' Form 3160-5 (April 2004)

1. Type of Well ☐ ☐ Gas Well ☐ ☐ Other			8. Well Name	and No.		
2. Name of Operator OXY USA Inc.	16696		Pure Gold	d D Federal # 13		
3a. Address P.O. Box 50250 Midland, TX 79710	3b. Phone No. (include area code) 432-685-5717		<b>30</b> -015- 7	Pool, or Exploratory Area

## Pure Gold D Federal 13 OXY USA Inc. November 12, 2011 Conditions of Approval

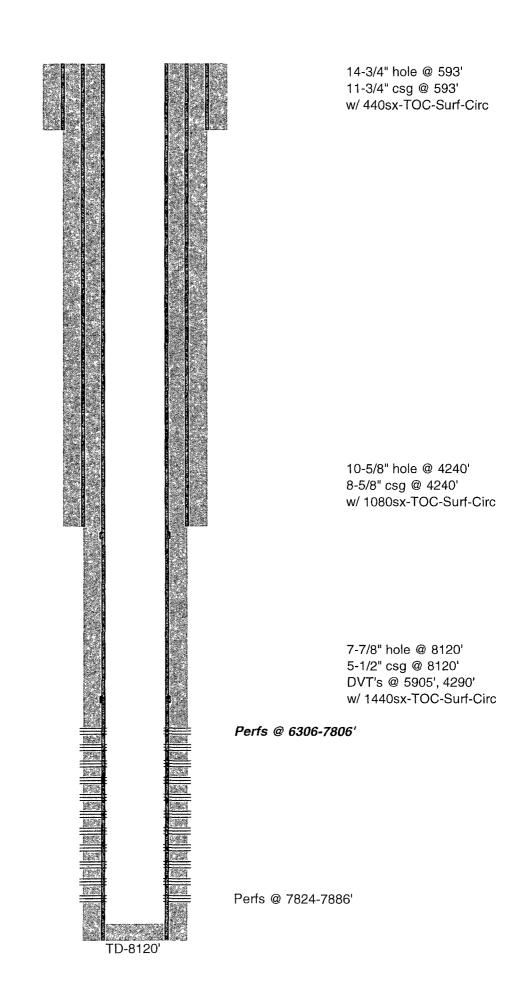
- 1. Surface disturbance beyond the originally approved pad must have prior approval.
- 2. Closed loop system required.
- 3. Operator to have H2S monitoring equipment on location.

- 4. A minimum of a 3000 (3M) BOP to be used. All blowout preventer (BOP) and related equipment (BOPE) shall comply with reasonable well control requirements. A two ram system with a blind ram and a pipe ram designed for the size of the work string shall be adequate. Tapered work strings will require an additional pipe ram. The manifold shall comply with Onshore Oil and Gas Order #2 Attachment I (3M Diagrams of Choke Manifold Equipment). The accumulator system shall have an immediately available power source to close the rams and retain 200 psi above pre-charge. The pre-charge test shall follow requirements in Onshore Order #2.

- 6. Operator limited to 3700 psi on the frac down the casing. This is based on 70% of the 5.5" 17# J-55 casing's burst rating.
- 7. Operator to submit a subsequent sundry with details of work performed including a new well test. Due to classification as one pool under order R-10086, no completion report is required.
